**CITY OF JOPLIN  
ADDENDUM NUMBER 2**

Date: 1/10/2020

Project Name: **City of Joplin Trail and Pedestrian Bridge STP-3201(705)**

1

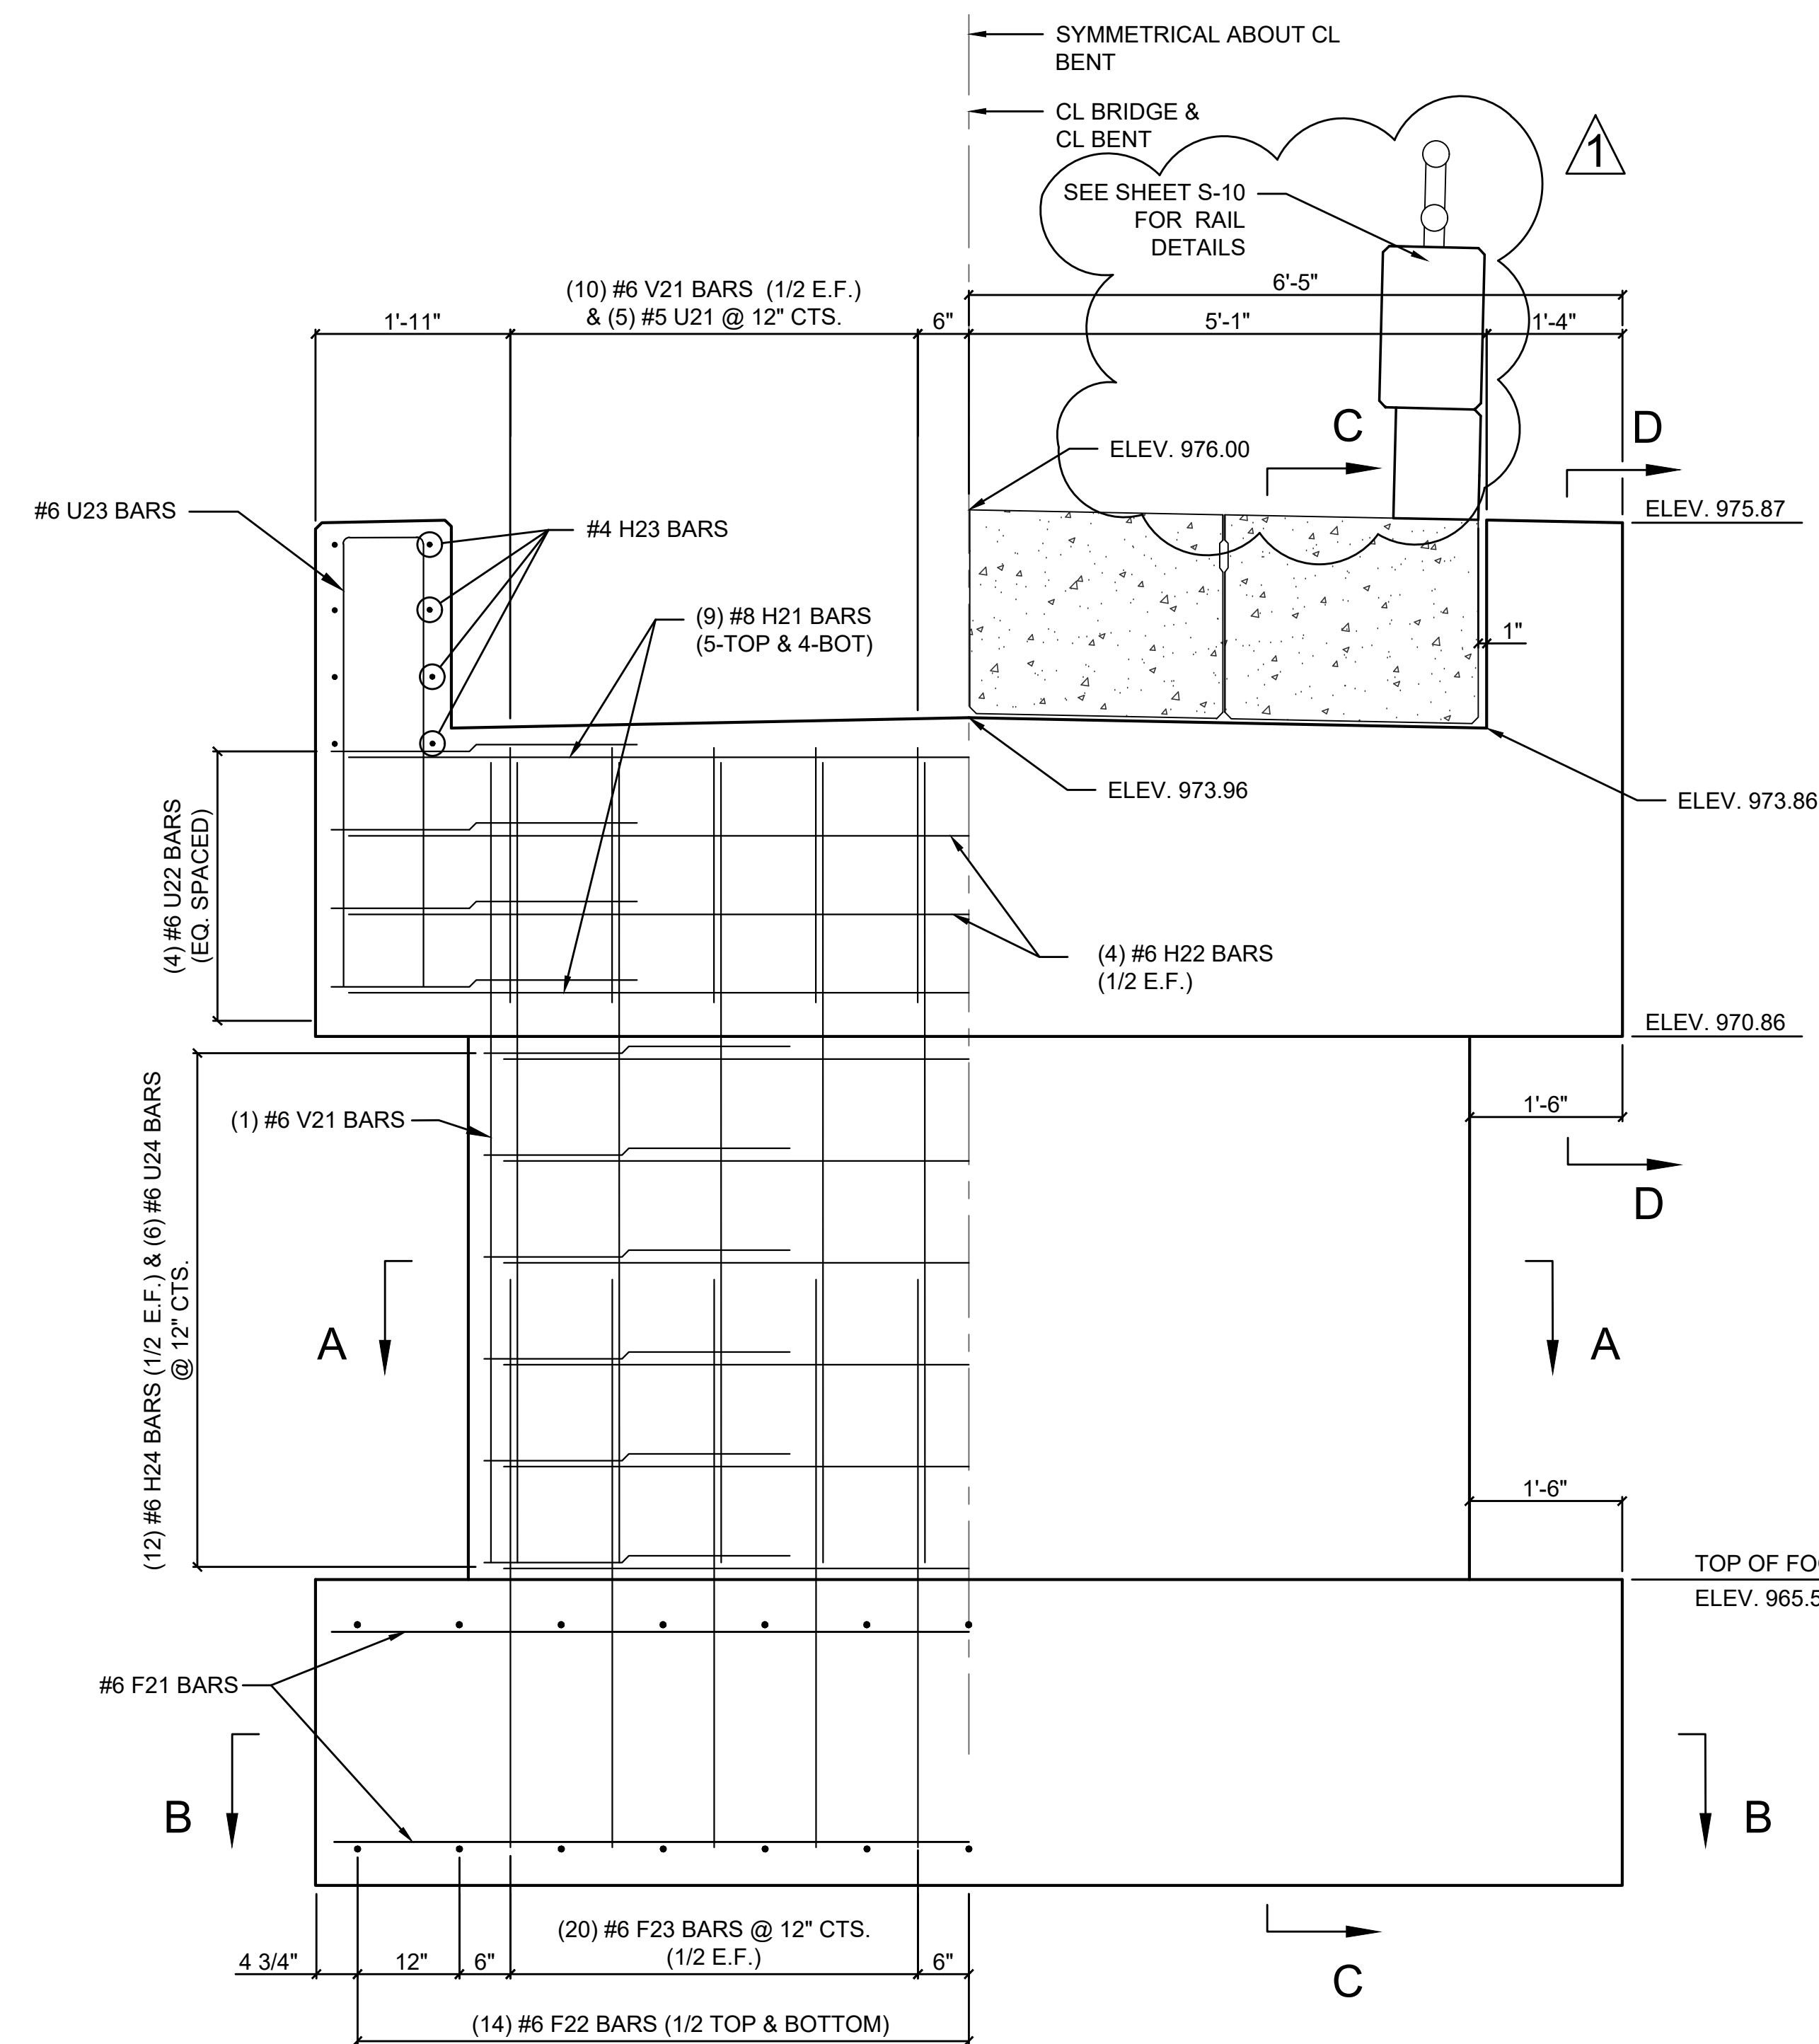
3. Multiple bridge plan sheets have been revised to include the addition of a modified concrete corral rail with pipe rails. The location of the stone veneer columns at the corners of the bridge has been revised as well.
